RS-14-207

Clinton Power Station, Unit 1  
Facility Operating License No. NPF-62  
NRC Docket No. 50-461

Subject: Third Six-Month Status Report in Response to March 12, 2012 Commission Order  
Modifying Licenses with Regard to Requirements for Mitigation Strategies for Beyond-  
Design-Basis External Events (Order Number EA-12-049)

**Third Six-Month Status Report for the Implementation of Order EA-12-049, Order  
Modifying Licenses with Regard to Requirements for Mitigation Strategies for Beyond-  
Design-Basis External Events**

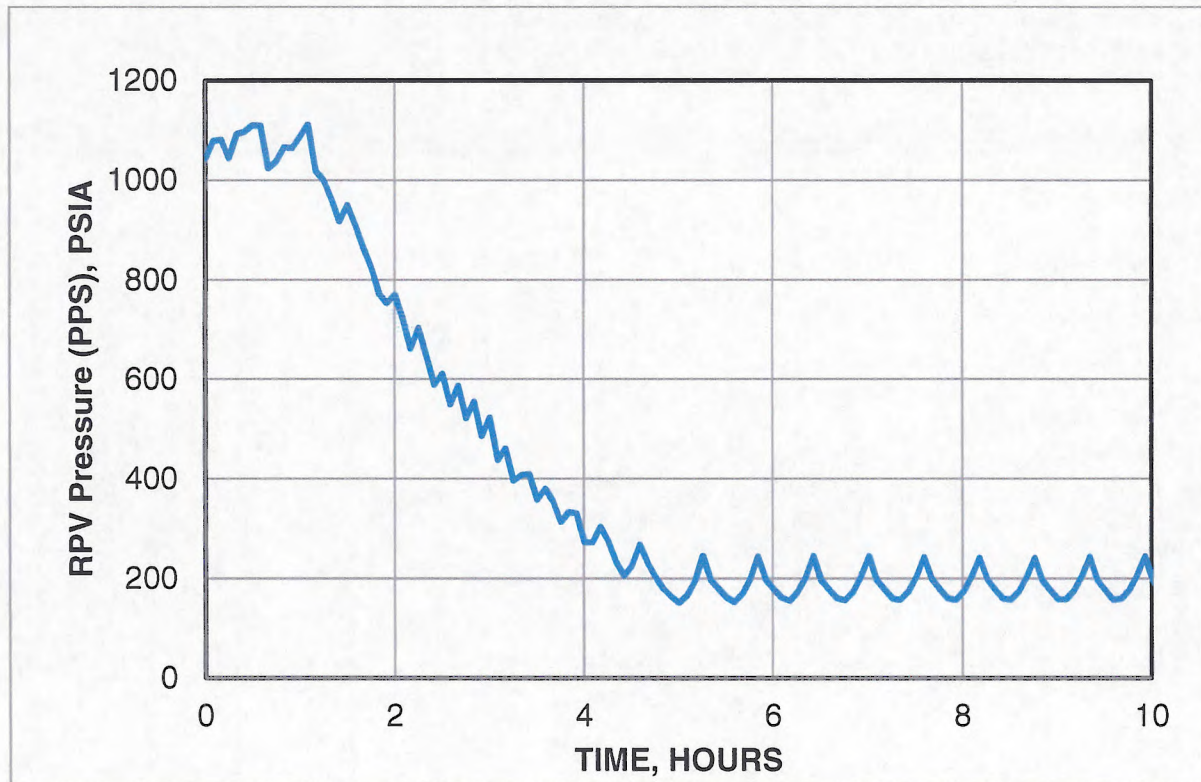
- (1) From the June 2013 position paper, benchmarks must be identified and discussed which demonstrate that MAAP4 is an appropriate code for the simulation of an ELAP event at your facility.*

#### Response to item 1:

Generic response provided by EPRI BWR Roadmap "Technical Basis for Establishing Success Timelines in Extended Loss of AC Power Scenarios in Boiling Water Reactors Using MAAP4," (EPRI Product ID [3002002749](#)).

**MAAP Calculation of Collapsed RPV Water Level Inside the Shroud**

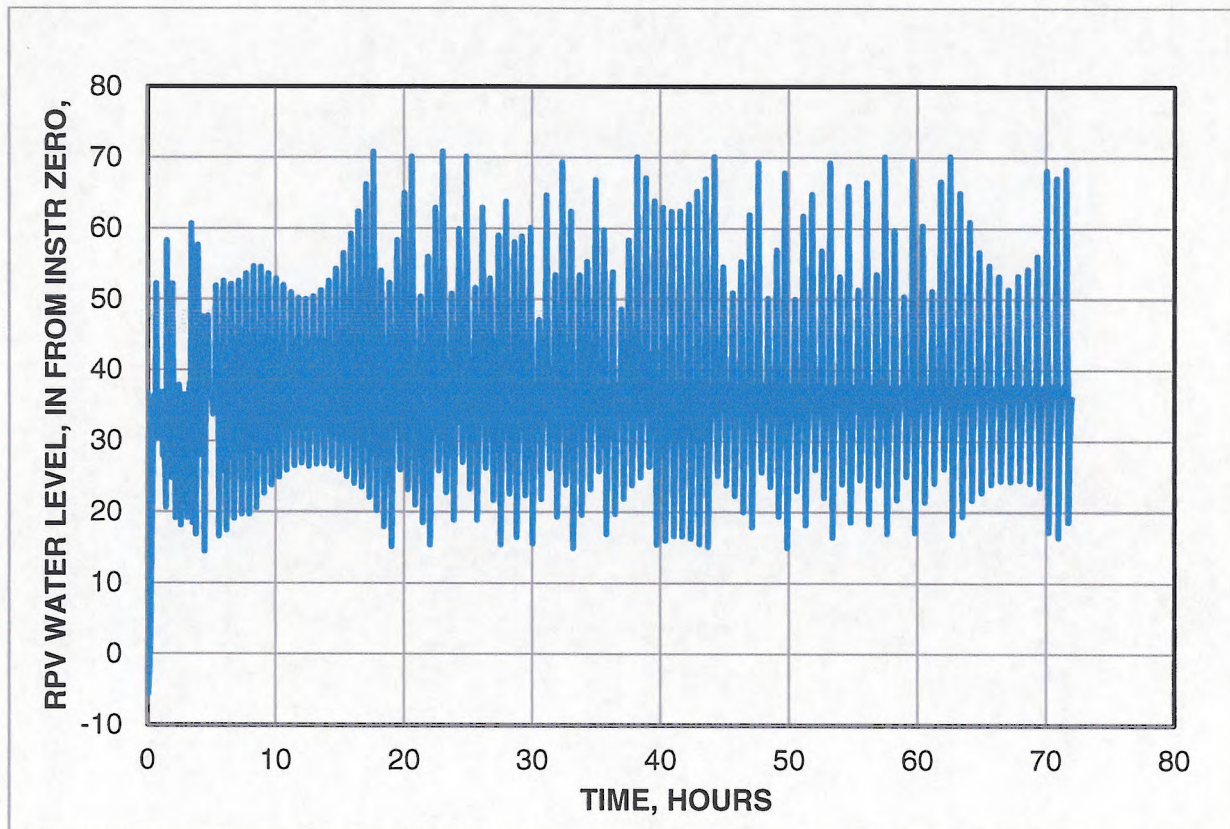
3.2.1.1.B	Collapsed level must remain above Top of Active Fuel and cool down rate must meet technical specifications.	<p>Information that validates the use of MAAP4 is contained in document <i>Forwarding of Clinton MAAP Justification for ELAP Analysis Acceptability</i> (Attachment 4) and is available on the ePortal.</p> <p><b>[Complete]</b></p>

For the representative MAAP run (Case 17), the collapsed RPV water level inside the shroud remains above TAF for the duration of the analysis. The plot below shows that the lowest RPV level, calculated by MAAP, is approximately -10" below instrument zero. (TAF is located at -162" relative to instrument zero<sup>(1)</sup>.) As shown in the following plot, the collapsed RPV water level remains at least 12' above TAF for the duration of the analysis.

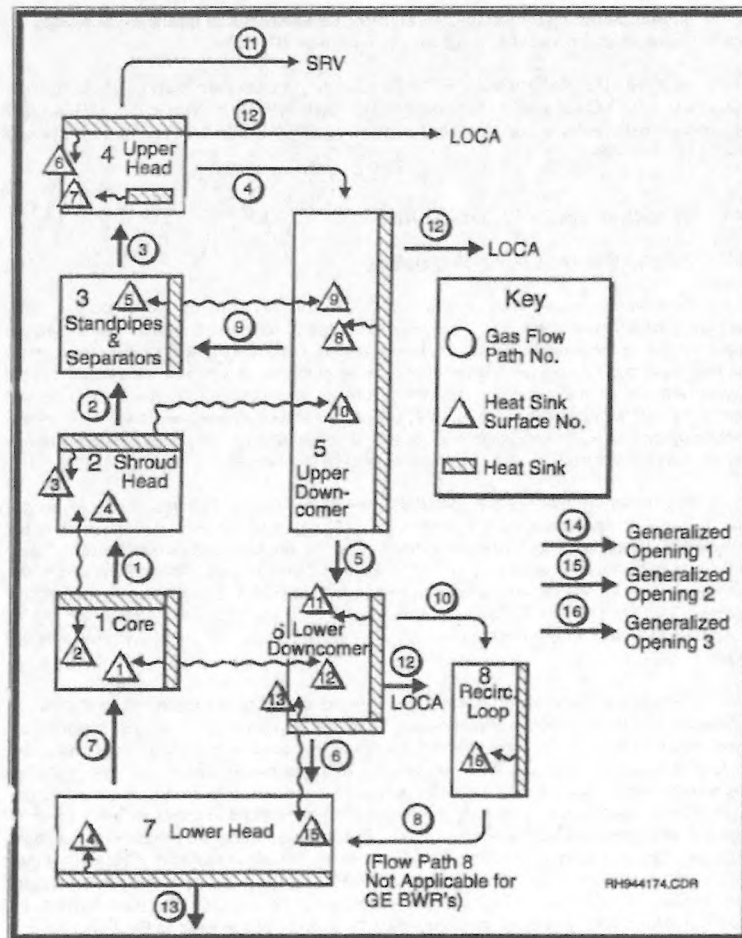
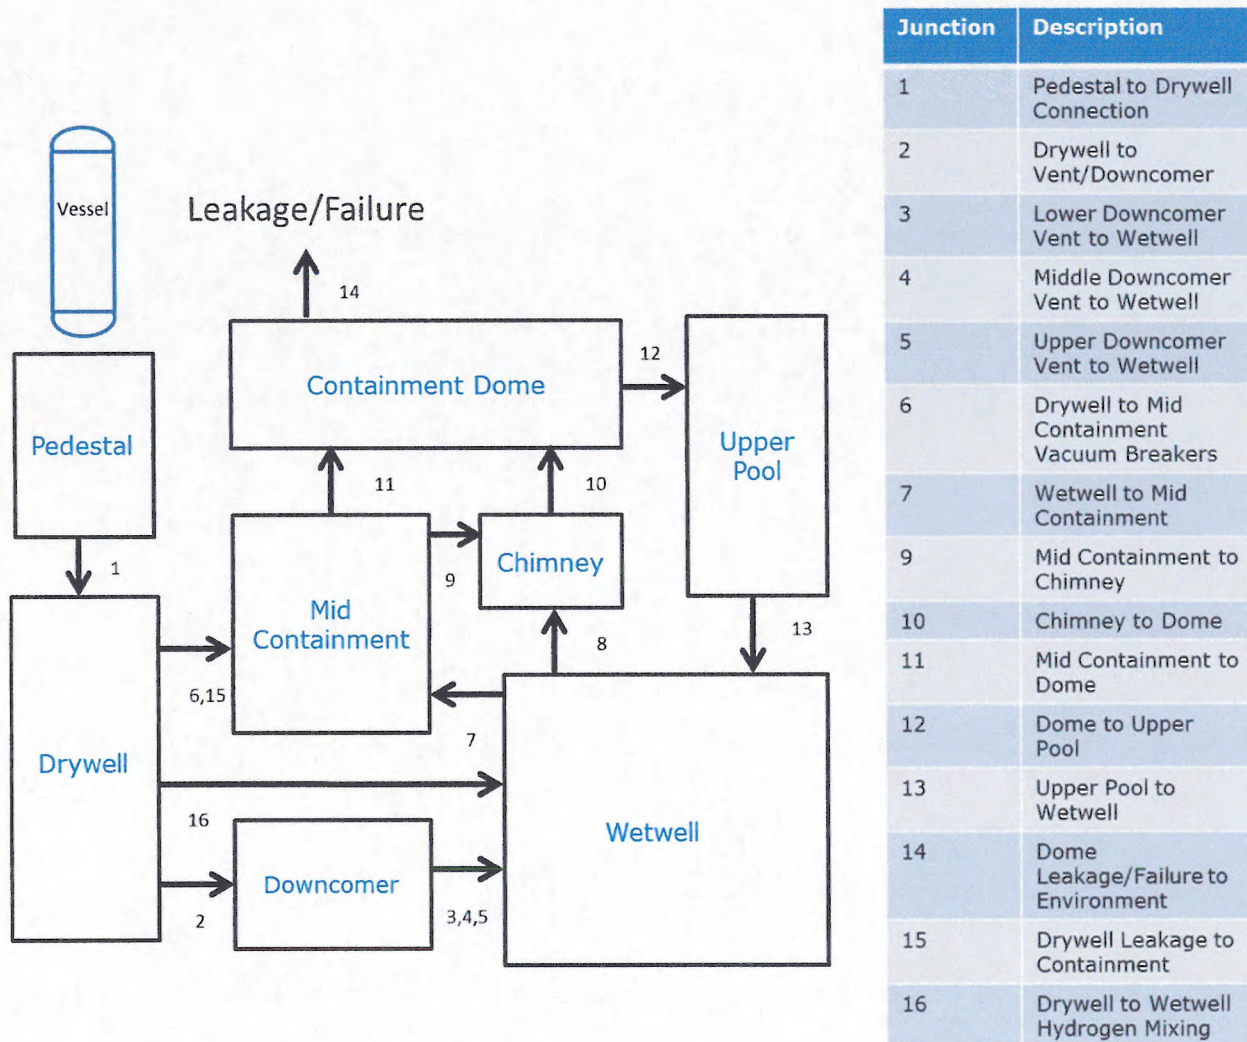
- (4) In using MAAP4, the licensee must identify and justify the subset of key modeling parameters cited from Tables 4-1 through 4-6 of the "MAAP4 Application Guidance, Desktop Reference for Using MAAP4 Software, Revision 2" (Electric Power Research Institute Report 1020236). This should include response at a plant-specific level regarding specific coding options and parameter choices for key models that would be expected to substantially affect the ELAP analysis performed for that licensee's plant. Although some suggested key phenomena are identified below, other parameters considered important in the simulation of the ELAP event by the vendor / licensee should also be included.

- a. The reactor vessel nodalization is fixed by the MAAP code and cannot be altered by the user, with the exception of the detailed core nodalization. The Clinton MAAP 4.0.5 parameter file divides the core region into 5 equal volume radial regions (See NCHAN) and 13 axial regions (See NAXNOD). The axial nodalization represents 10 equal-sized fueled nodes (see NROWS), 1 unfueled node at the top (see NNFT), and 2 unfueled nodes at the bottom (see NNFB). The figure below, taken from the MAAP Users Manual, illustrates the vessel nodalization scheme.

Containment nodalization is defined by the user. The standard nodalization scheme is used in the Clinton MAAP 4.0.5 parameter file and represents the following individual compartments:

1. Reactor pedestal region
2. Drywell
3. Drywell vents to suppression chamber
4. Suppression chamber (wetwell)
5. Containment chimney
6. Containment dome
